FILE P. I. Nos. 0006870, 0006869, and 0006861
Cobb County
CSSTP-0006-00(870), (869), and (861)
Big Shanty Connector and Widening of
Big Shanty Road

SUBJECT **APPROVED PROJECT CONCEPT REPORT**

Subject: Project Concept for CSSTP-0006-00(870)(869)(861), Big Shanty Road Connector and Widening, Cobb County

We have reviewed your May 11, 2006 subject Project Concept Report and offer the following comments.

FIGURE 1

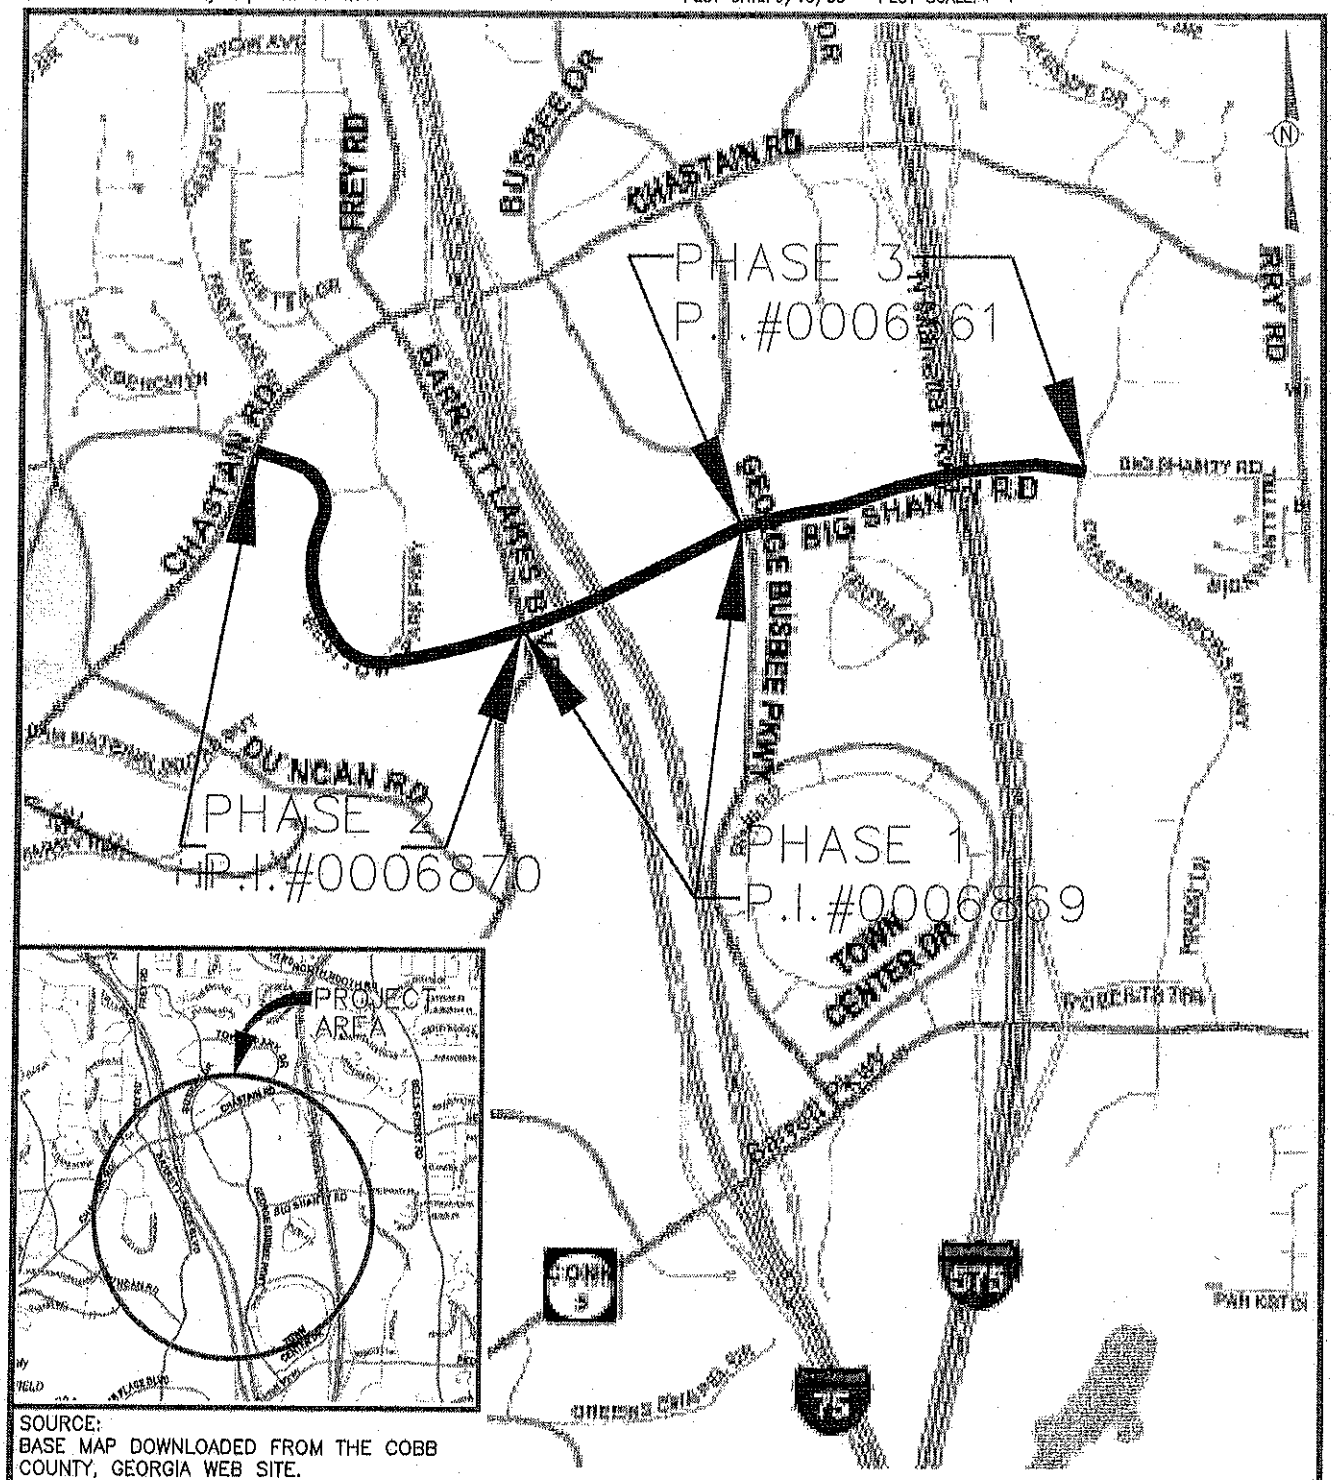
5. Project Location Map – Provide an inset showing more details. Show phases of construction. Add page header to be consistent with rest of report.
